Airworthiness Directives; MD Helicopters, Inc. Model 369D, 369E, 369F, and 369FF Helicopters

ACTION: Notice of proposed rulemaking (NPRM).

MD Helicopters, Inc.: Docket No. 2001-SW-40-AD. Revises AD 2002-13-05, Amendment 39-12793.

Figure 1 - Inspection Location

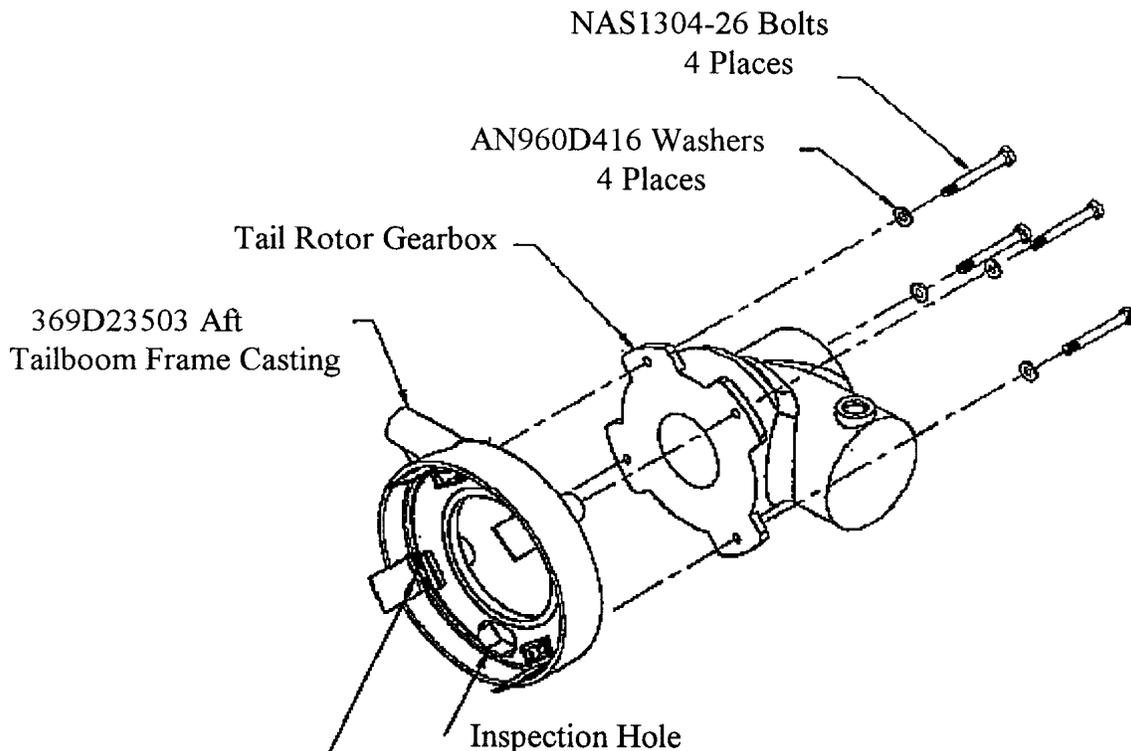
(2) Remove the tailboom control rod and determine the number of bolt threads protruding from each nutplate on the internal surface of the aft tailboom frame casting, P/N 369D23503, as shown in Figure 1 of this AD. At least one thread must protrude. If more than four threads protrude, add an additional washer, P/N AN960D416, under the bolt head. Torque the bolt to 100–110 in-lbs, and reapply a slippage mark. See Figure 1:

Inspect this area of each bolt.
Bolt must protrude at least one thread past end of nutplate 4 places.

(b) Between 2 and 10 hours TIS after accomplishing the requirements of paragraph (a) of this AD, inspect the torque on each bolt by applying 100 in-lbs. If any bolt movement occurs, retorque the bolt to 100–110 in-lbs. Reapply a slippage mark to the bolt regardless of the outcome of the torque test. Reinspect the torque between 2 and 10 hours TIS thereafter until no bolt movement occurs.
